Mobile Intel® Pentium® 4 Processor-M and Intel® 852GM Chipset Platform

Design Guide Update

April 2005

Document Number: **305341-002**

1. System Memory SMVREF Design Update

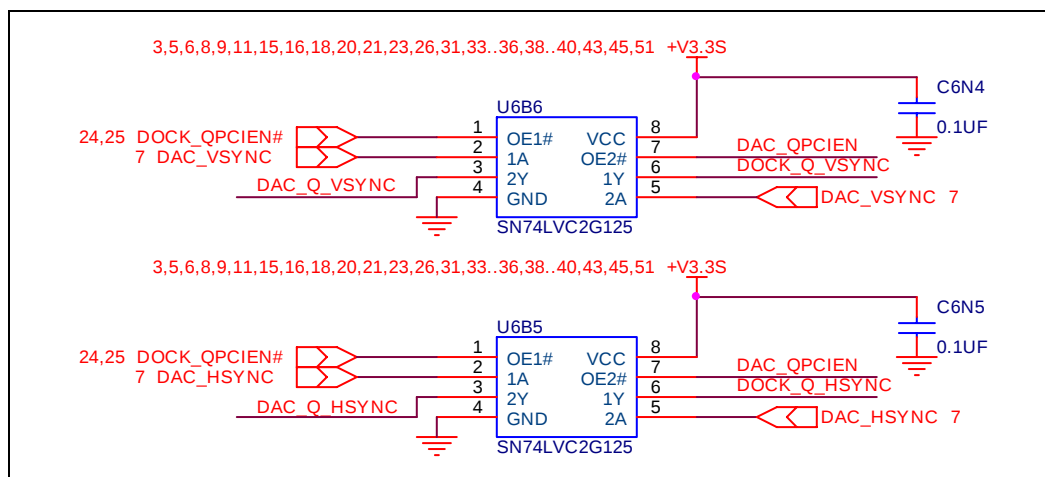
SMVREF is required to be on during S3. Without valid SMVREF to GMCH, CKE lines may float high during S3. Section 11.5.3.5 “DDR SMRCOMP and VTT 1.25-V Supply Disable in S3/Suspend” should be updated as follows.

*SMRCOMP and VTT 1.25V supplies can be disabled during the S3 suspend state to further save power on the platform. This is possible because the GMCH does not require resistive compensation during suspend. However, the 2.5-V VCCSM power pins of the GMCH, the **SMVREF** pin of the GMCH, and the VDD power pins of the DDR memory devices are required to be on in S3 state. Note that **some DDR memory devices may or may not require a valid reference voltage during suspend**. It is the responsibility of the system designer to ensure that requirements of the DDR memory devices are met.*

2. Correction on Pinout/Connection for Processor Power

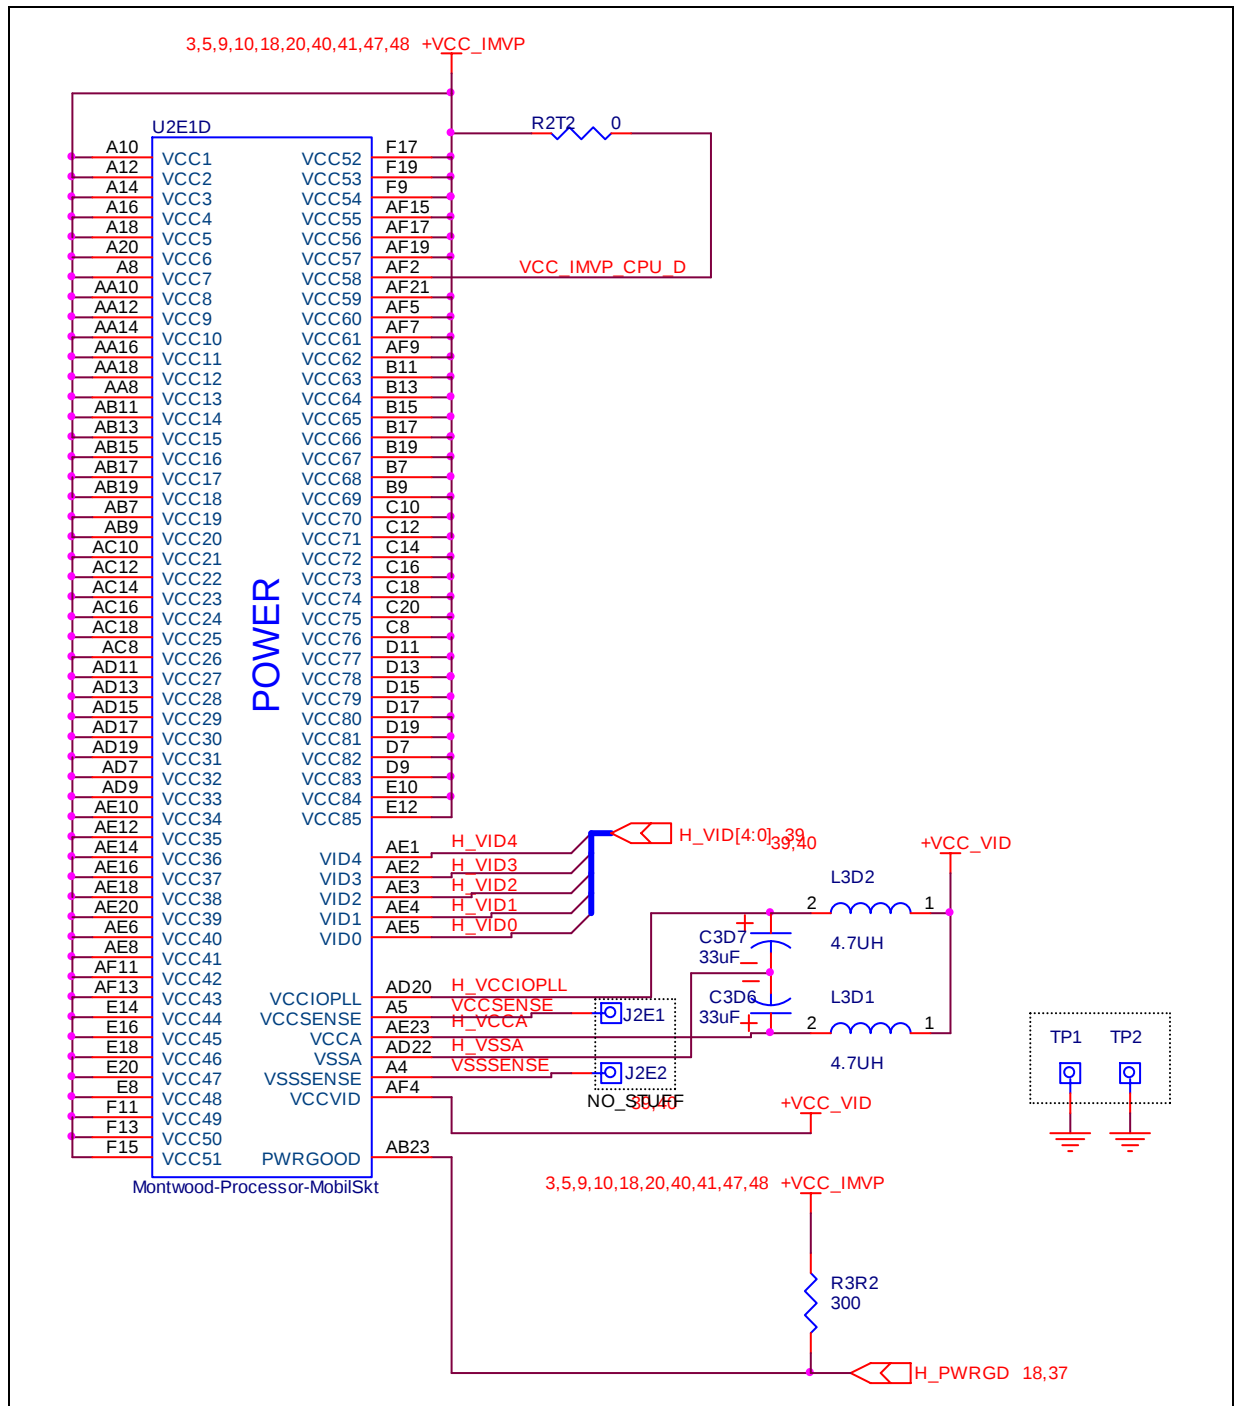
Schematics net connections for VCCA and VCCIOPLL for the Processor power should be corrected as follows (schematics sheet 4).
